## Product Change Notice (PCN)

**Subject:** Product marking change from Ink Mark to Laser Mark

**Publication Date:** 7/21/2022

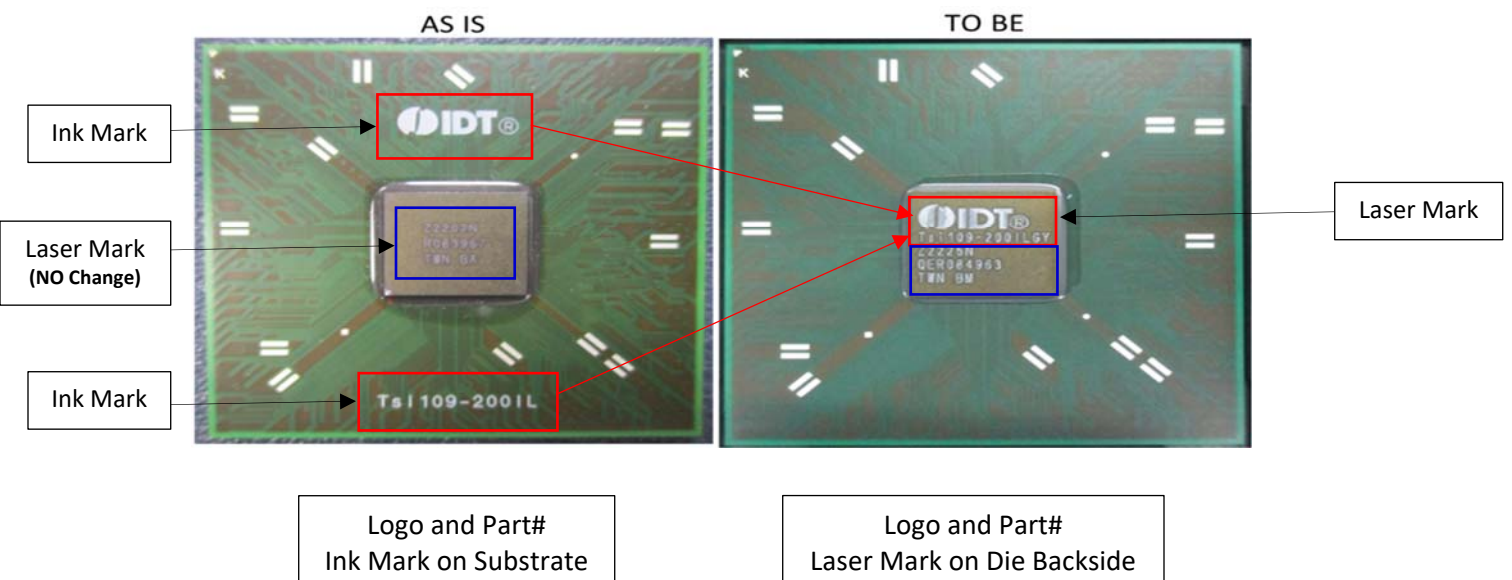
Renesas is changing from ink mark to laser mark on select products as a result of marking ink being phased out. Presently, “IDT” logo and product part# are ink marked on the substrate. This two information will change to laser marked on the die backside.

No change to the rest of marking as highlighted in blue box depicted in the below image.

Refer below for the marking appearance comparison.

The change will have no impact on the fit, function, quality, reliability and environmental compliance of the products. However, the form in specific the marking appearance is changed as shown in the above images.
